**AMENDMENT 1**

TIBET ROAD  
(TRIBUTARY T TO E. 48TH AVE.)  
SITE PLAN FOR INFRASTRUCTURE  
TITLE: LANDSCAPE PLAN  
DATE: January 30, 2023

TIBET ROAD (TRIBUTARY T TO E. 48TH AVE.)  
SITE PLAN FOR INFRASTRUCTURE  
TITLE: LANDSCAPE DETAILS  
DATE: January 30, 2023

TIBET ROAD  
(TRIBUTARY T TO E. 48TH AVE.)  
SITE PLAN FOR INFRASTRUCTURE  
TITLE: LANDSCAPE PLAN  
DATE: January 30, 2023

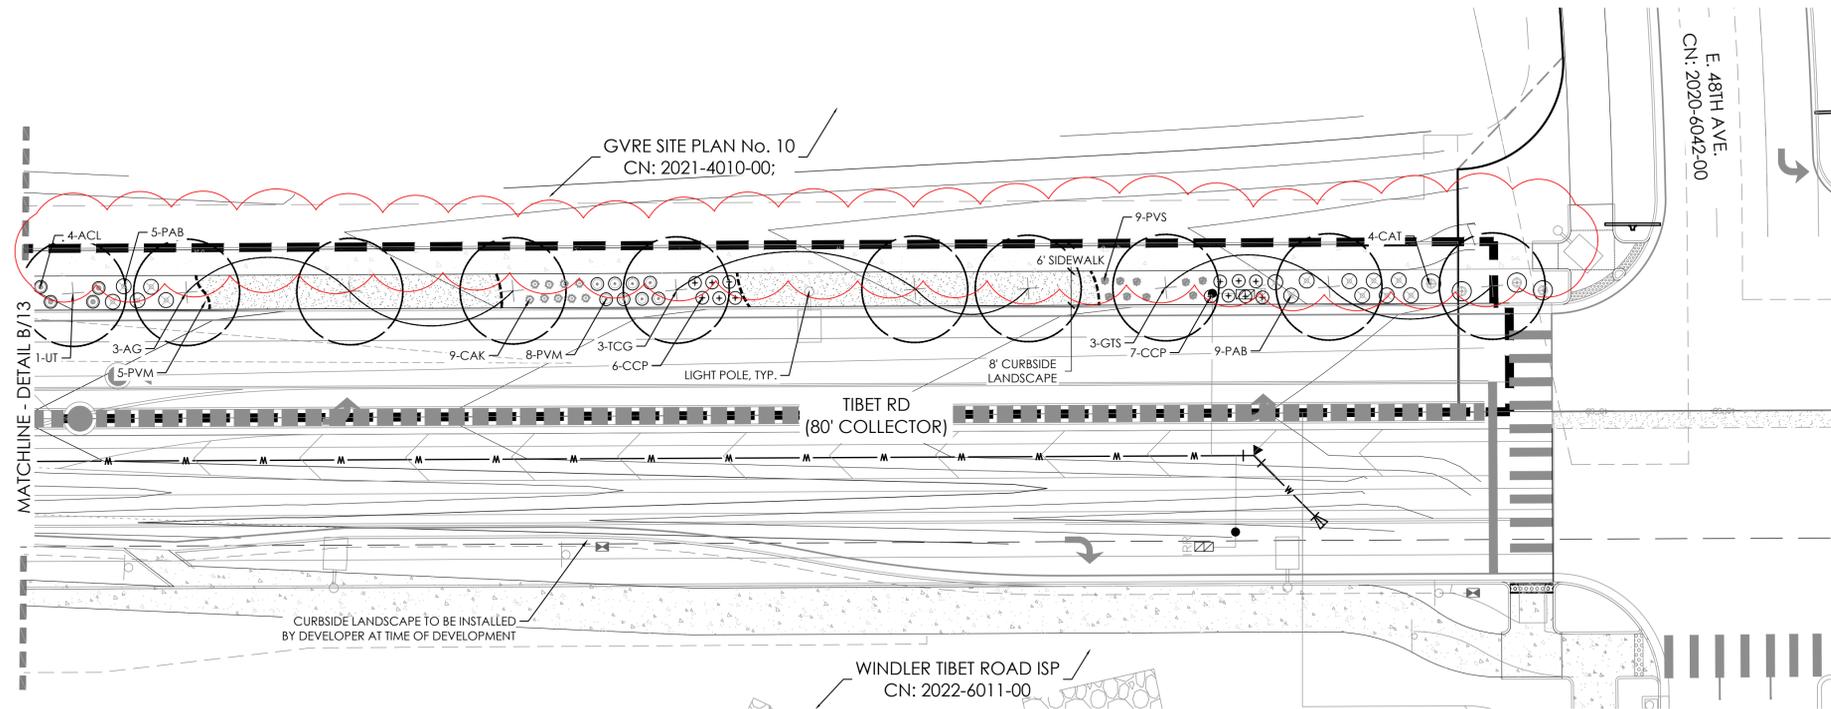
**AMENDMENT 1**  
- REMOVE CRUSHER FINES BIKE PATH

4 LIGHT POLE AND FIXTURE  
SCALE: NTS

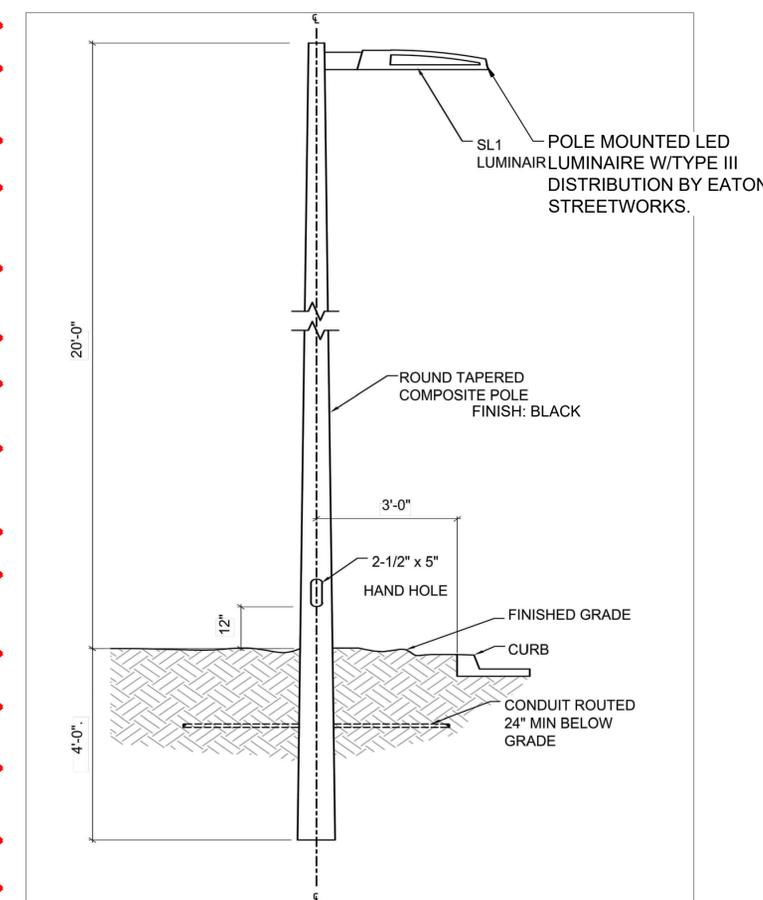
**1**  
AMENDMENT 1  
- REMOVE CRUSHER FINES BIKE PATH  
- MOVED DETAILS TO SHEET 14  
- ADDED STREET LIGHT DETAILS
